299 Wilson Street  
Ashland, Massachusetts  
EDC Job No.: 3595

In response to a peer review by GCG Associates, Inc., dated November 4, 2022, we are providing an attached response to comments in red.

# Rock Riprap Lined Waterway Design - Cut/Paste Plan

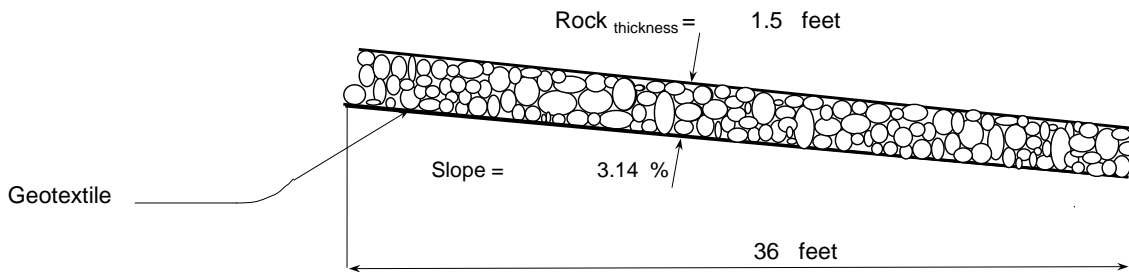
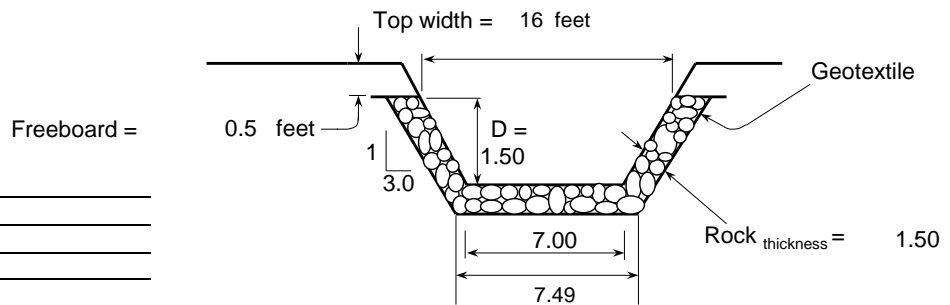
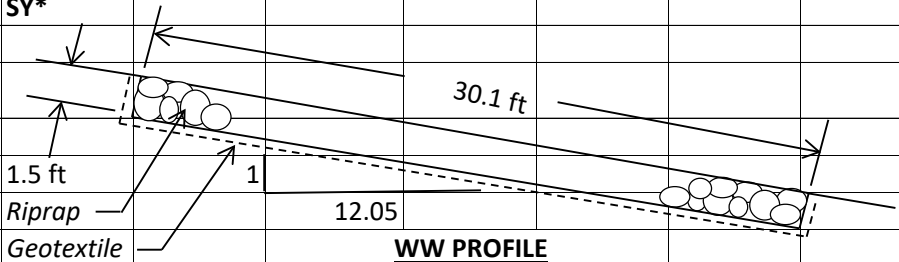
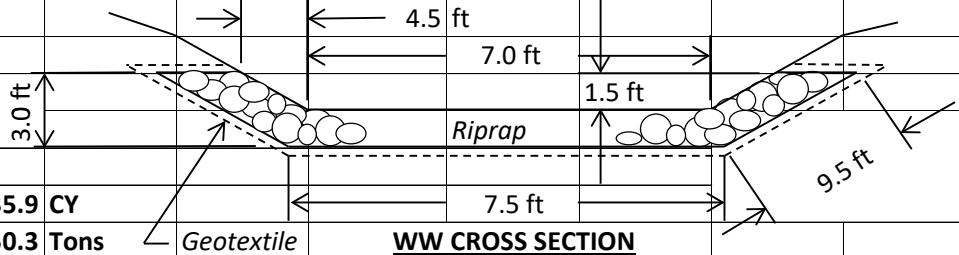
6. The last page of the Notice of Intent package included a NRCS Rock Riprap Lined Waterway Design – Cut/Paste Plan, which shows an 8-foot-wide bottom channel with 2.5' depth and 18 feet top width. Applicant should clarify the applicant and location of this waterway design. **This detail has been replaced with the 36"x30" riprap downstream detail.**

# Rock Riprap Lined Waterway Design - Cut/Paste Plan

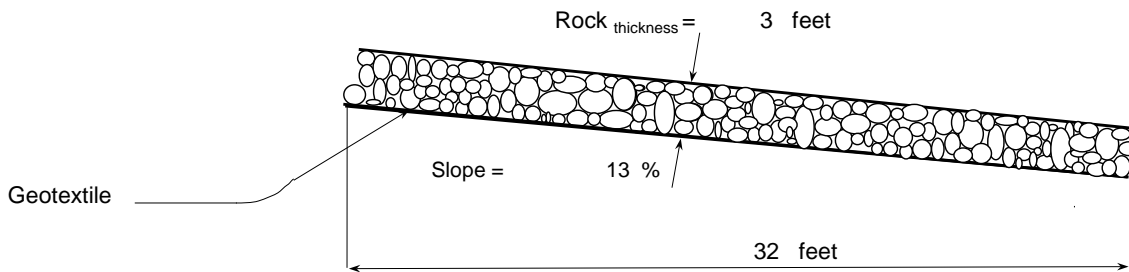
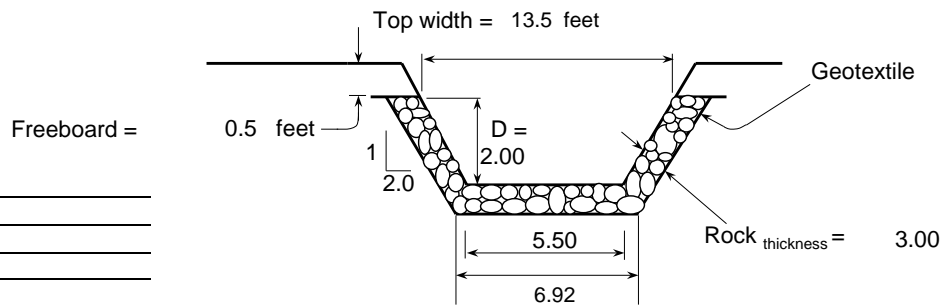
4. Existing 36” CMP (corrugated metal pipe) replacement should provide additional information which should include the following.
    - a. Identify the existing 3.5’W x 3’H box culvert lower invert elevation and analysis the maximum flow rate and velocity and sizing the concrete-riprap apron/channel accordingly, apron/channel dimensions, longitudinal slope, inverts should be specified on the plan. Channel should be sized to maintain the design flow within the armor section and sizing the downstream riprap apron width and length accordingly. **The invert is inaccessible, estimated invert elevation is 304.5. The channel design is based on the maximum flow the culvert will carry without overtopping the roadway. See attached calculations using NRCS based spreadsheet. The 36” CMP has a lower capacity than the 36” x 30” box culvert, so the less restrictive flow value was used.**
